**Coal Combustion Residue Impoundment
Round 11 - Dam Assessment Report**

Allen Fossil Plant

Tennessee Valley Authority
Memphis, Tennessee

Dewberry & Davis LLC
Fairfax, Virginia

Pseudostatic Slope Stability Analysis
CCP Storage Facilities - Existing Conditions
Tennessee Valley Authority Fossil Plants

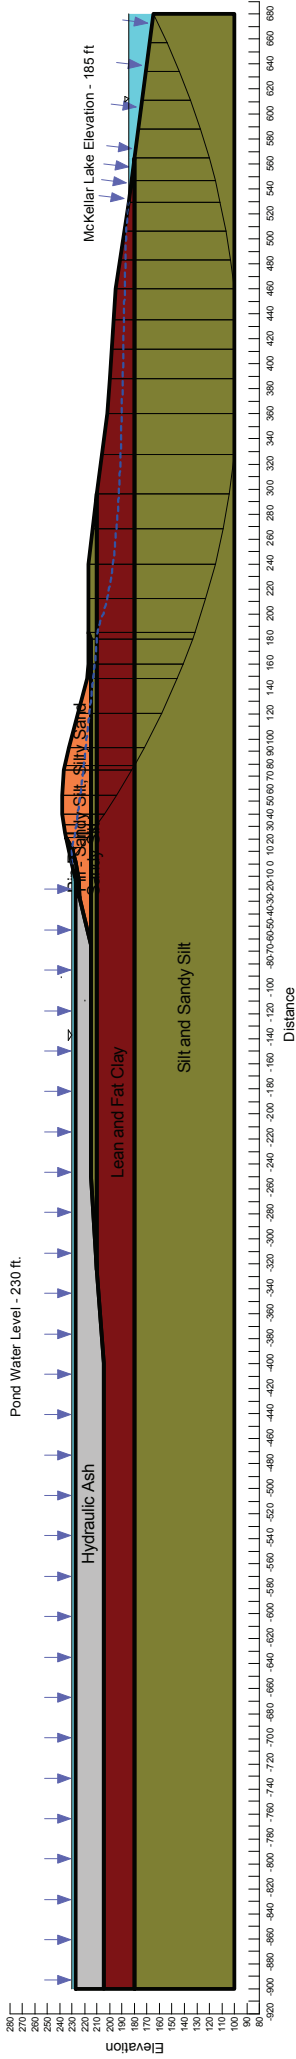
The furnished pseudo-static slope stability analysis results show that the East Ash Pond dike embankments are substandard with respect to seismic stability for an earthquake even less than that required by EPA for a Significant hazard impoundment. For the “design” seismic coefficient $k_h = 0.127$ (indicated as the 500-year return period event), the dike embankments at the Allen Plant are shown to have $FS < 1.0$, indicating failure. The dikes are shown to have $FS = 1.0$ (the acceptance criterion) for return times of 250 years and 370 years for the northern perimeter dike and eastern perimeter dike, respectively. The New Madrid earthquakes have a return period of approximately 450 years. Thus, these dikes are

Factor of Safety: 0.73
Horizontal Seismic Coefficient $K_h = 0.127\text{ g}$
500-year Return Period Event

- 1) Perform appropriate seismic stability analyses that use the USEPA design earthquake criterion for Significant hazard impoundments (i.e., earthquake with 2,475-year return period). Provide the basis and reasoning for the “design” seismic coefficient used in further pseudo-static slope stability analysis or perform a higher level of analysis that uses more sophisticated methods.
- 2) Review/evaluate liquefaction potential and, if necessary, perform a quantitative liquefaction analysis.
- 3) If it is determined that liquefaction is not likely, review/investigate the very soft to soft soils in the alluvial foundation beneath the dike embankments, evaluate deformation potential during the design earthquake, and assess the impact of any such deformation on the stability of the embankment.
